Work Order ID 80136

Item Name: Crosstube Aft

DRAWING NO. D412-664-243	TITLE CROSSTUBE ASSEMBLY (412 HI AFT)	REV. E	DART AEROSPACE LTD ENGINEERING ORDER		D.E.O. NO. D412-664-243-E-1	SHEET NO. SHEET 1 OF 2	SCALE NTS
DRAWN	CHECKED <i>MP</i>	MFG. APPR. <i>E</i>	APPROVED <i>MP</i>		DE APPR. <i>MP</i>		
DATE 11.03.31	DATE 11/03.31	DATE 11.03.31	DATE 11/03.31		DATE 11.03.31

DRAWING NO. D412-664-243	TITLE CROSSTUBE ASS'Y (412 HI AFT)	REV. E	DART AEROSPACE LTD ENGINEERING ORDER		D.E.O. NO. D412-664-243-E-2	SHEET NO. SHEET 1 OF 1	SCALE NTS
DRAWN 92	CHECKED ASS	MFG. APPR. E	APPROVED MP		DE APPR. H		
DATE 11.09.07	DATE 11.09.19	DATE 11.09.19	DATE 11.09.19		DATE 11.09.19

**D412-664-243
ASSEMBLY DETAIL**

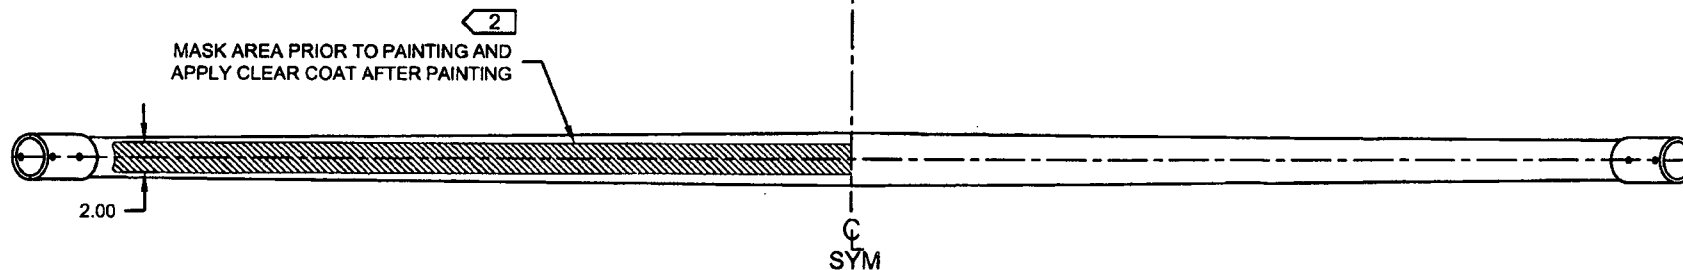
PURPOSE:

REMOVED ABRASION STRIP IN FAVOR OF A THIN LAYER OF PROSEAL 890.

IS:

16 14
D3189-1 CHAFING SHIELD (1, INSTALLED OVER PROSEAL 890)
MS21920-28 CLAMP, 2X
2 PL

WAS:

14 16
D2856-600-1009 ABRASION STRIP
D3189-1 CHAFING SHIELD (1, INSTALLED OVER ABRASION STRIP)
MS21920-28 CLAMP, 2X
2 PL

CRUSHING OF D412-664-243

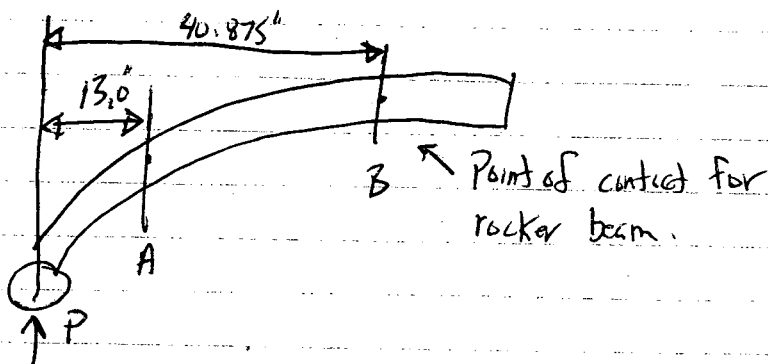
Acceptability of 8% CRUSHING AT END OF BEND

Point A: $OD_1 = 2.961"$, $OD_2 = 2.522"$

$$CRUSHING = (2.961 - 2.522) / (2.961 + 2.522) = 8\%$$

A: $F = M_c / I = P \times 13 \times 2.961 / 2 \times 1.676 = 11.484 \cdot P$

B: $" = P \times 40.875 \times 3.307 / 2 \times 4.613 = 14.651 \cdot P$

$$M.S. = 14.651 / 11.484 - 1 = 0.27$$

∴ Tube will break at rocker beam contact before area of 8% crushing, 8% crushing in area at end of tube bend is acceptable
